## REPORT TO COMMON COUNCIL

**Item:** Final Plat – North Edgewood Estates 2

The North Edgewood Estates 2 Final Plat, as shown on the attached maps, **BE APPROVED** subject to the following conditions:

## LOCATION MAP

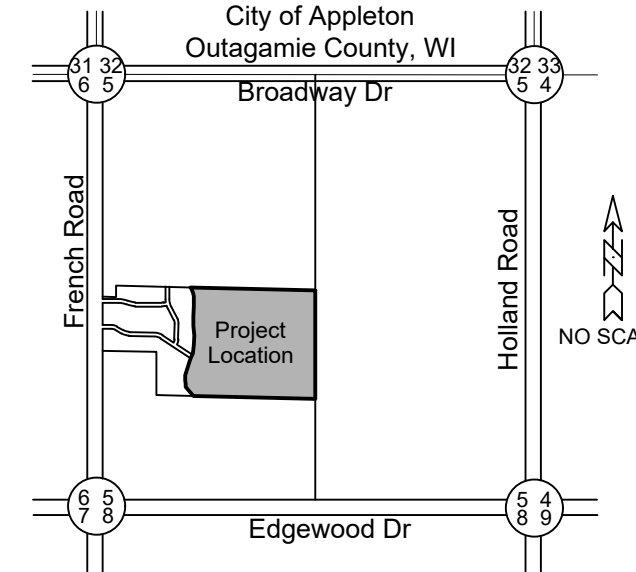
6. The 35’ | 35’ labels shown for Acadia Drive appear to be incorrect. Revise as necessary.
7. The Location Map in the upper right corner should be updated.

File: 5641Final2.dwg  
Date: 05/12/2020  
Drafted By: jim  
Sheet: 1 of 3

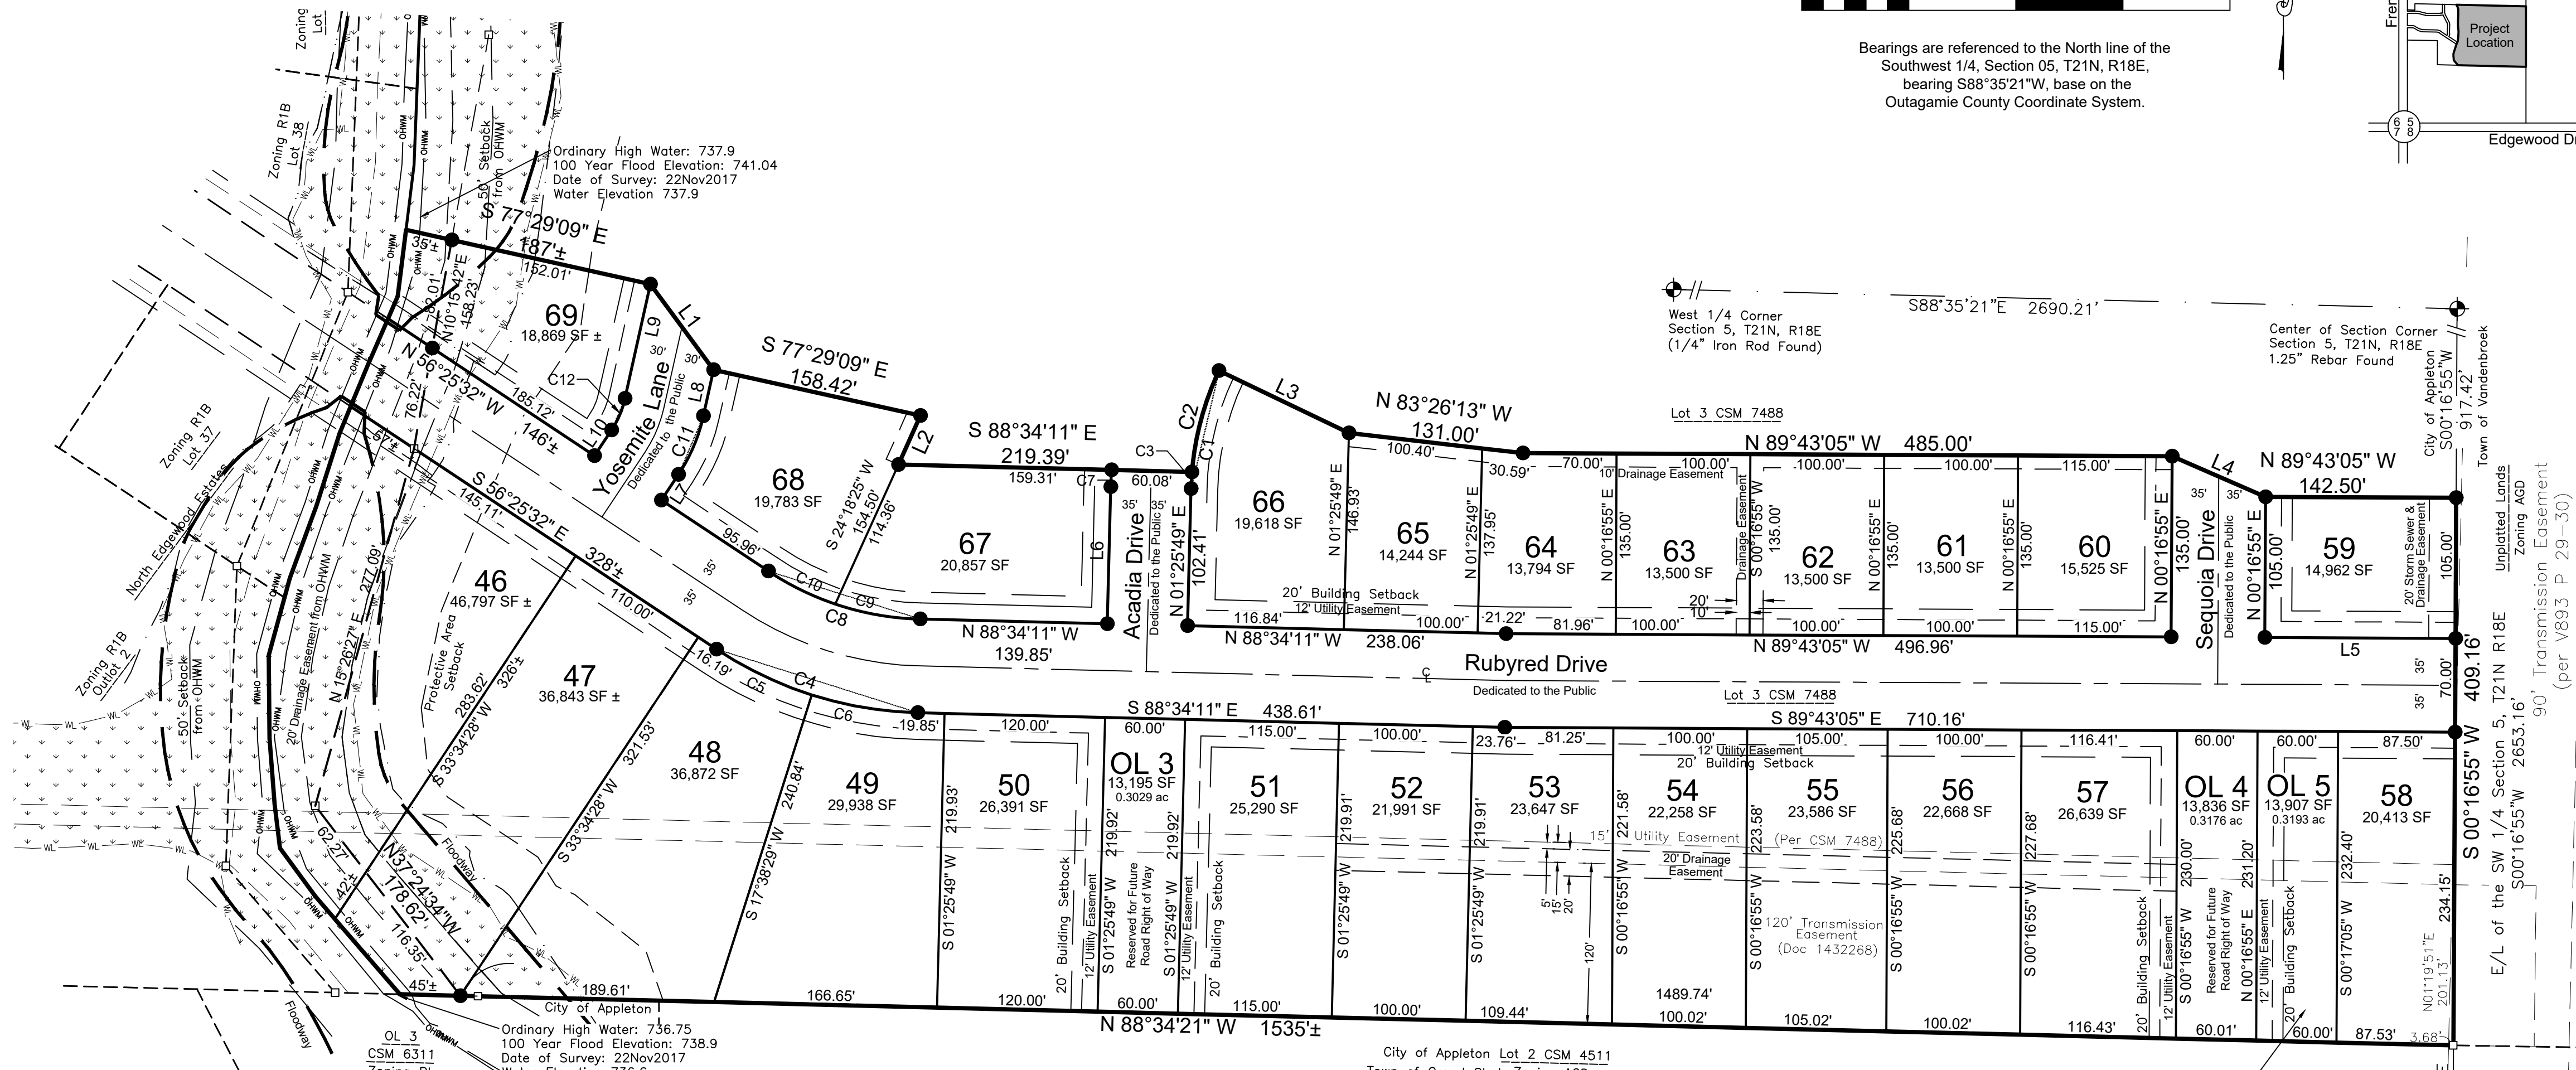
4. There is a “City of Appleton” label on the wrong side of the corporate limit line. Revise as necessary.
5. For the south line of Lot 69, the dimensions listed appear to be incorrect and no distance is shown between the meander line and Plat boundary.

12. Reference elevations to NAVD 88 not NGVD 29.
13. In the Legend on sheet 1 list the outside diameter of iron pipes found or set.
14. The bar scale on sheet 1 and 2 does not appear to be correct, revise as necessary.

15. No distance is shown for the meander line angle point in Lot 46 to the Plat boundary, revise as necessary.
16. The dimension of set monuments listed in the legend does not meet City ordinance minimum standards.

17. Add the State of Wisconsin public trust note to the Plat.
18. Add the word easement to item number 8 in the Notes list on sheet 1.
19. Revise the description on top of sheet 1 of the Plat that states “All of Lot 3” to read Part of Lot 3.

Revision Date: May 12, 2020  
 File: 5641Final2.dwg  
 Date: 05/12/2020  
 Drafted By: jim  
 Sheet: 2 of 3

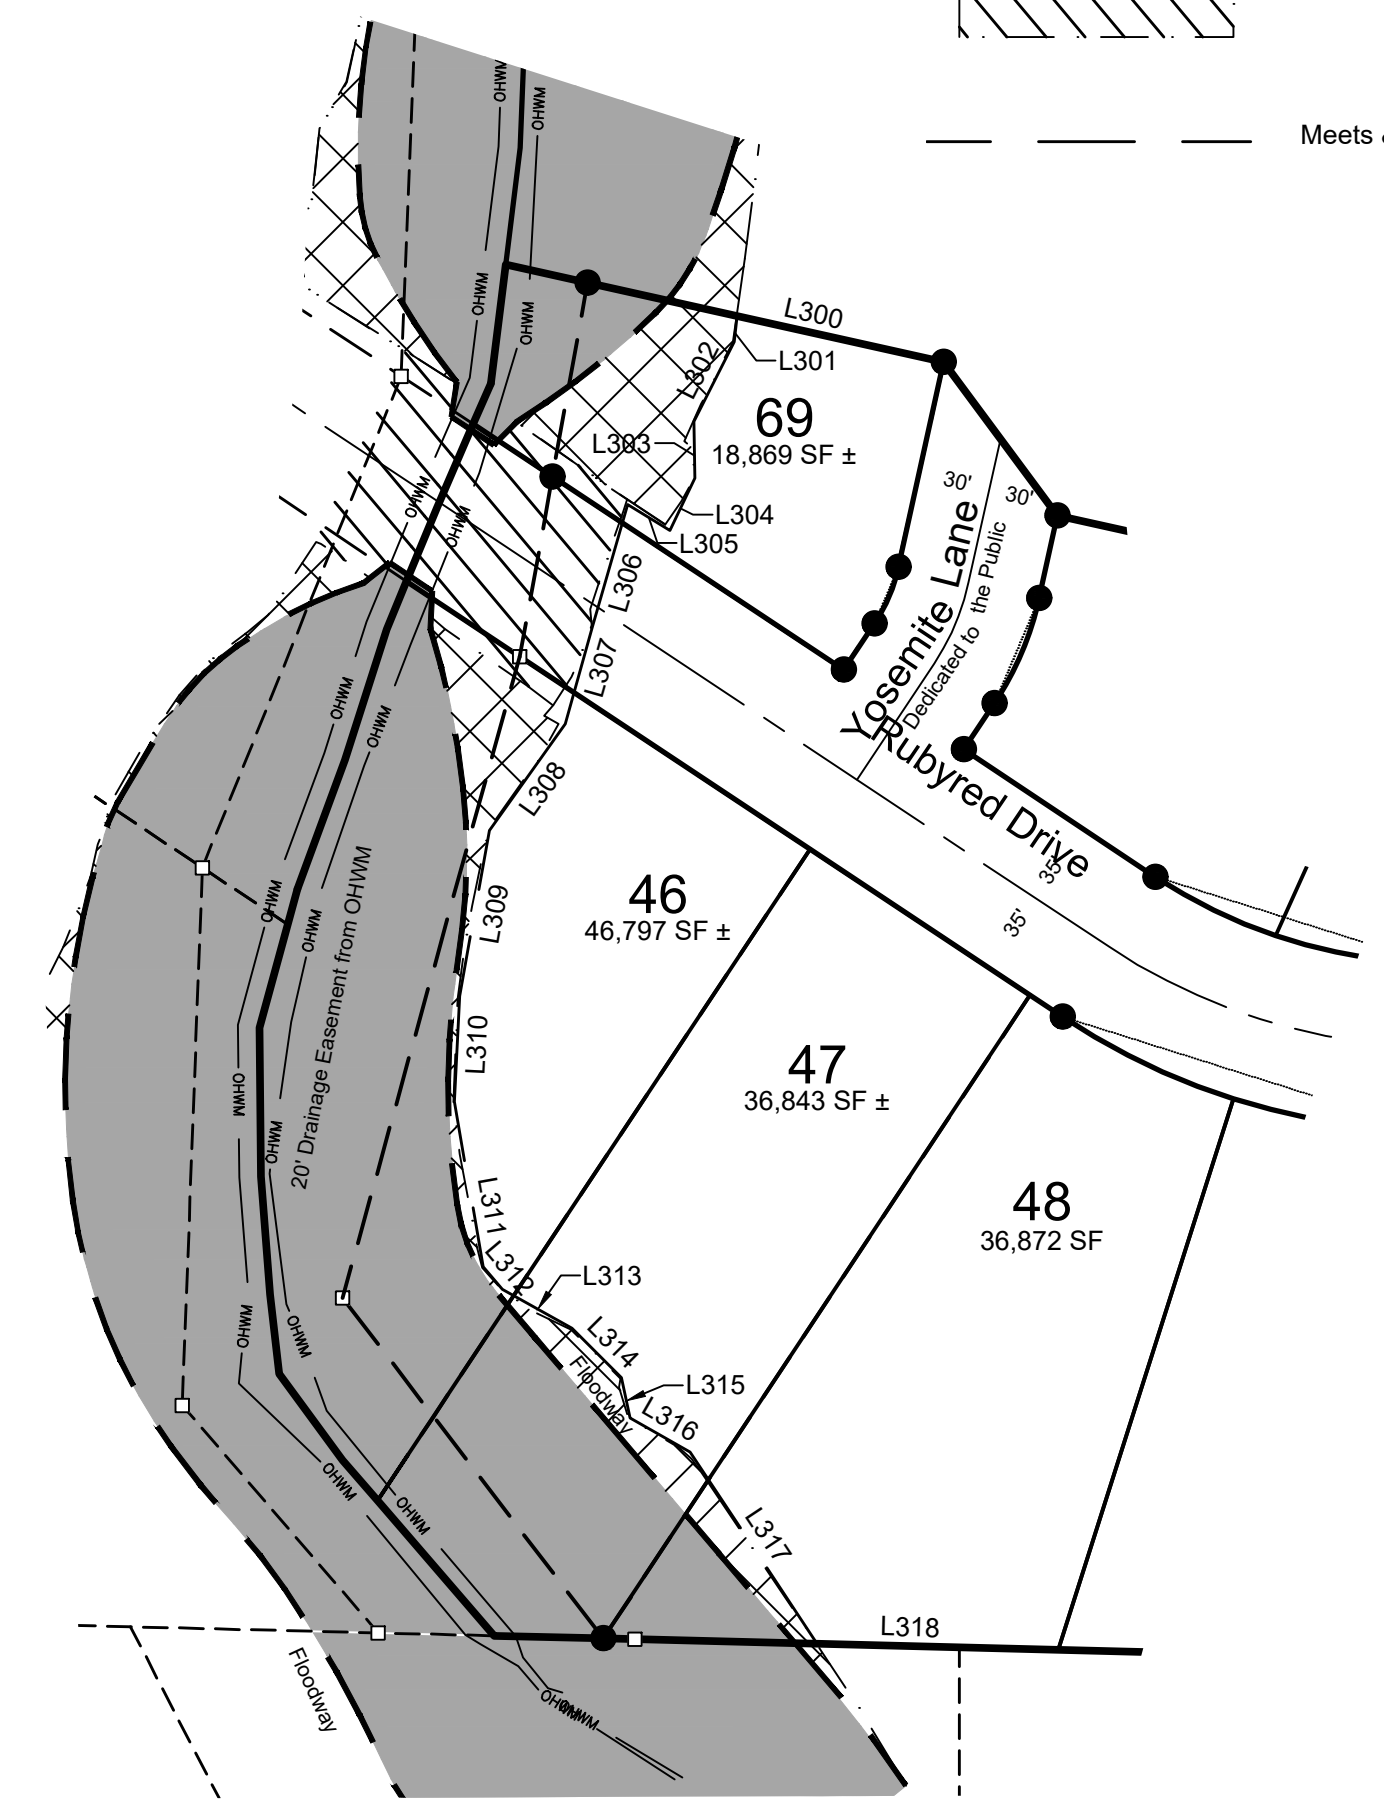
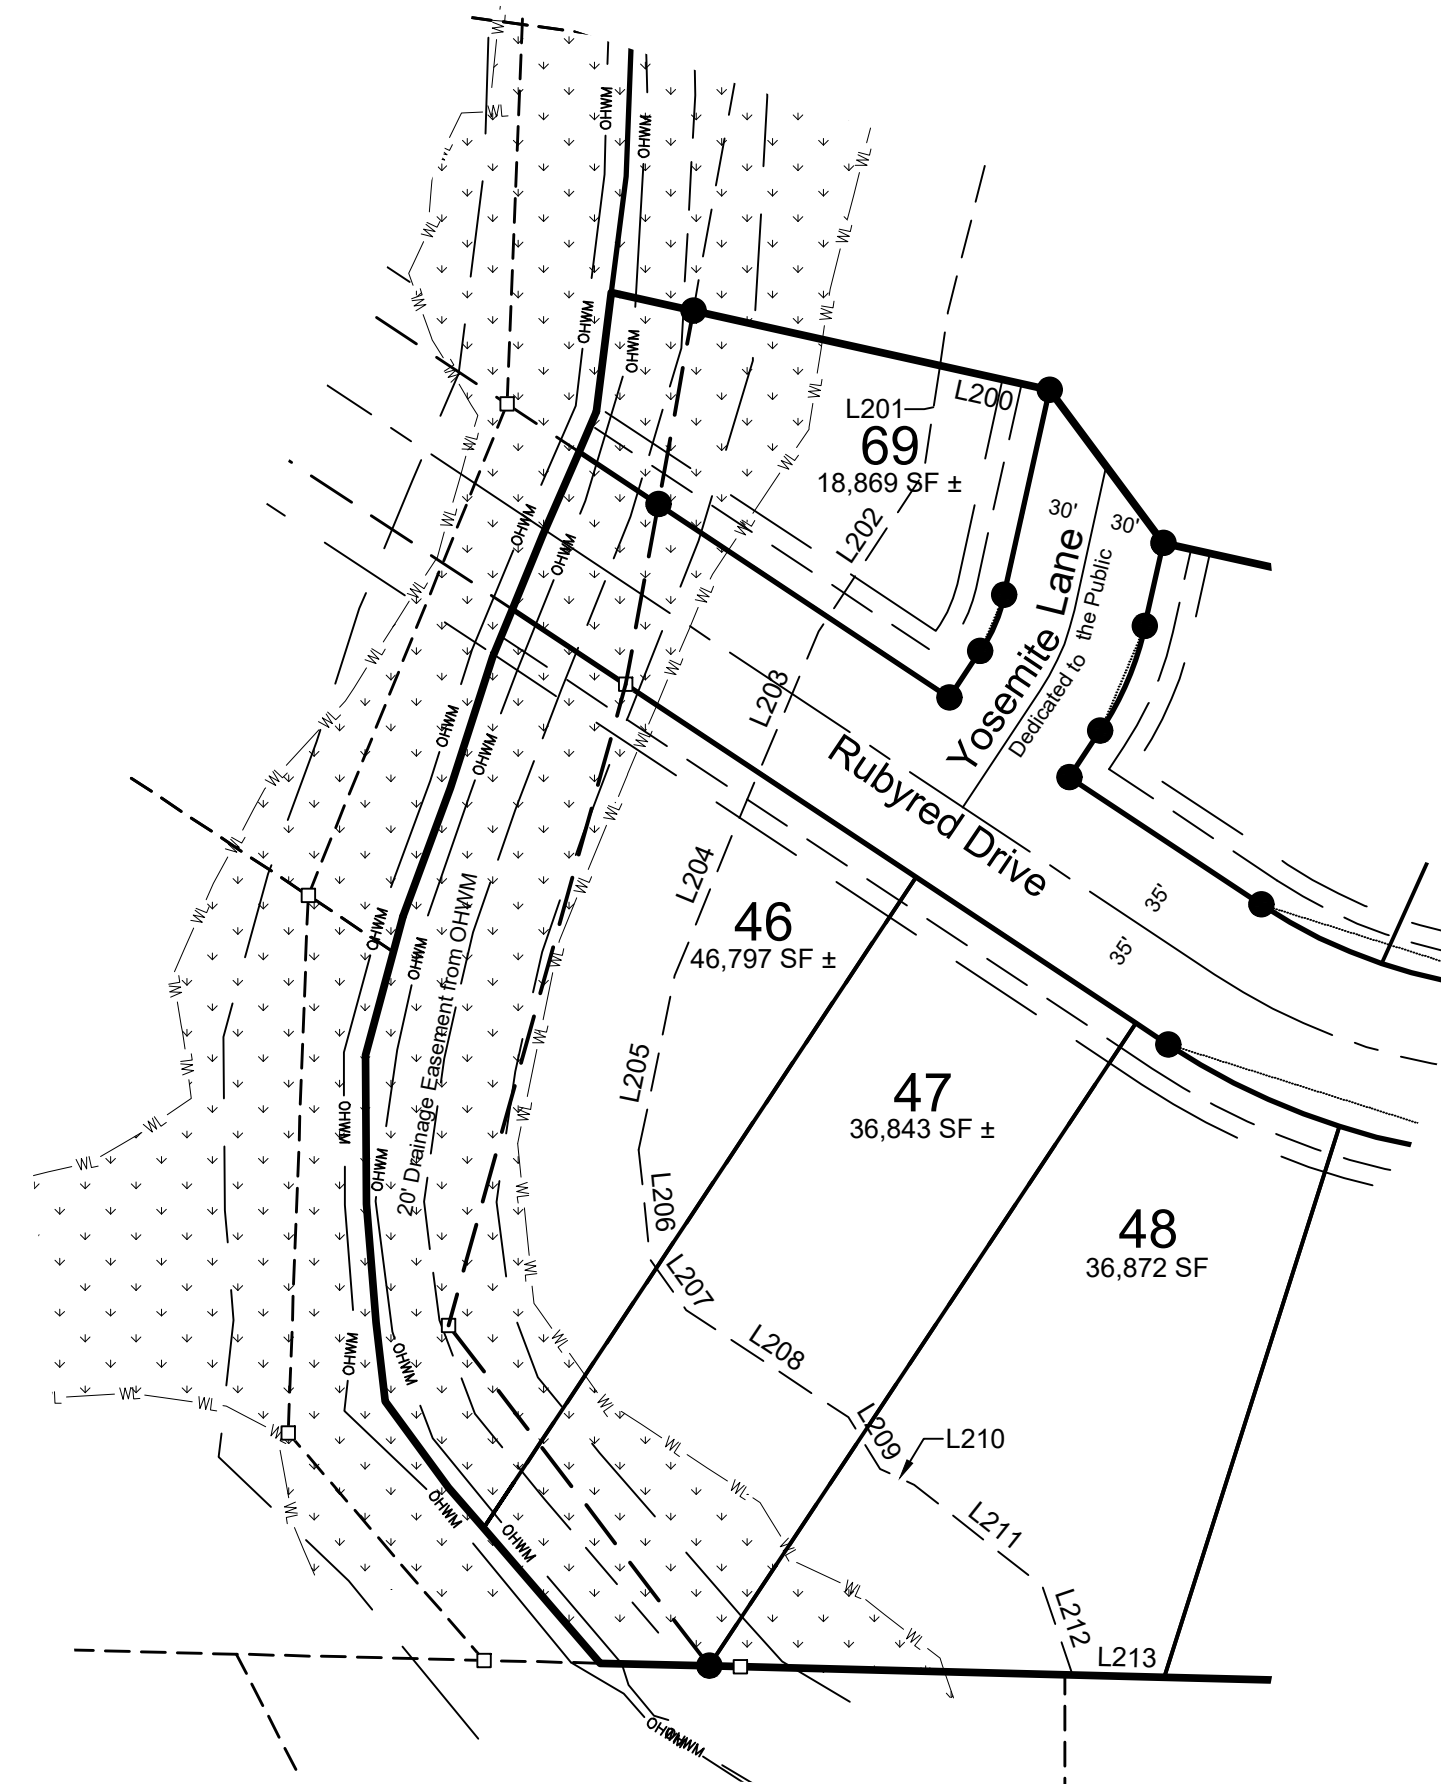
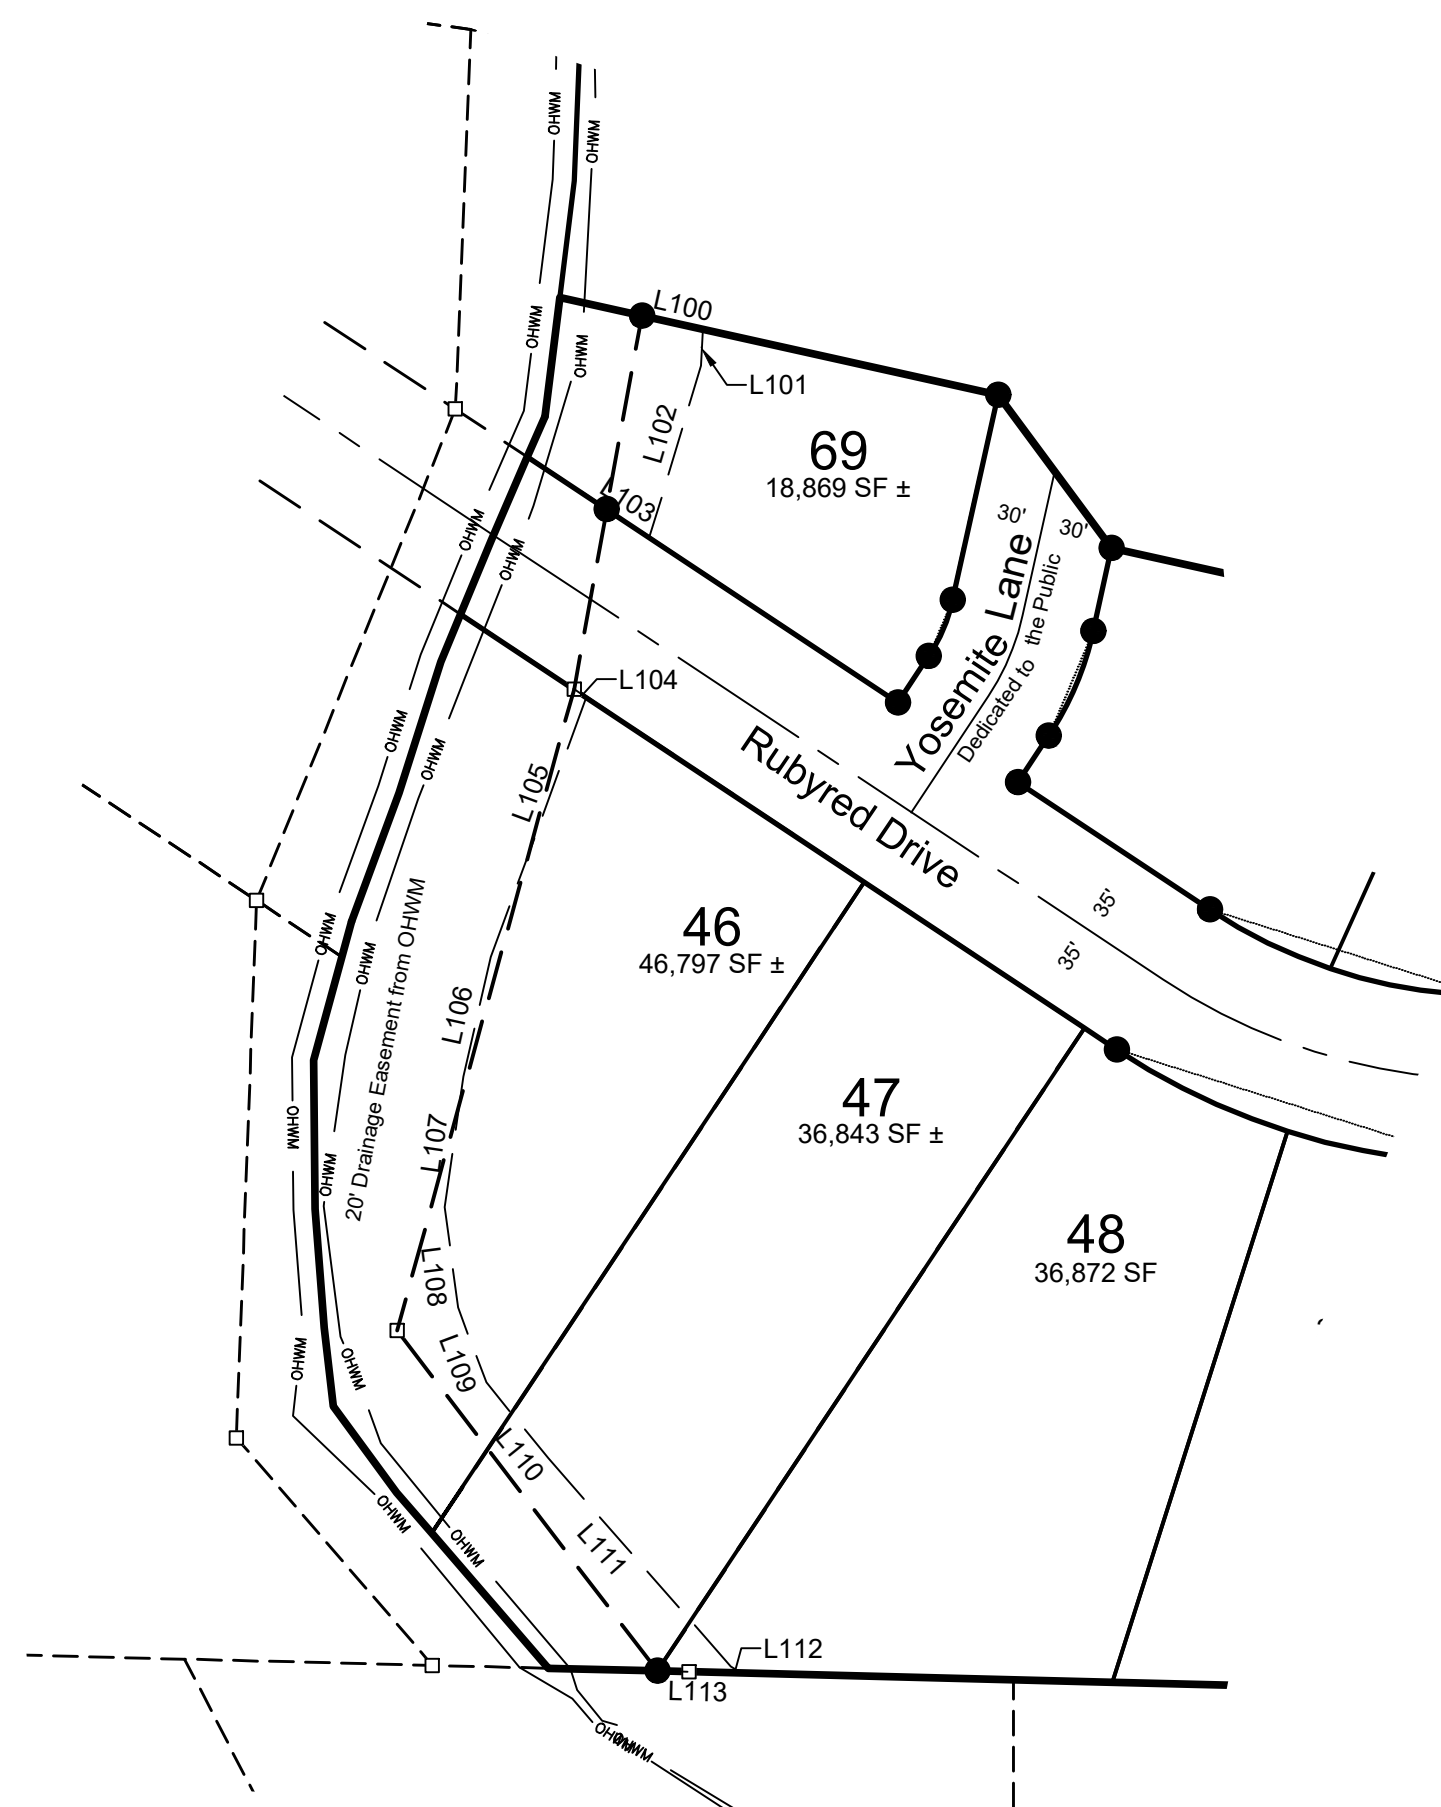
10. The Stormwater Permit review letter included comments on Wetlands and 100-year water surface elevations that are yet to be addressed. Based on the pending resubmittal, additional comments may be forthcoming on the Wetlands/Shoreland Zoning/Floodplain Exhibit Sheet for the Final Plat.
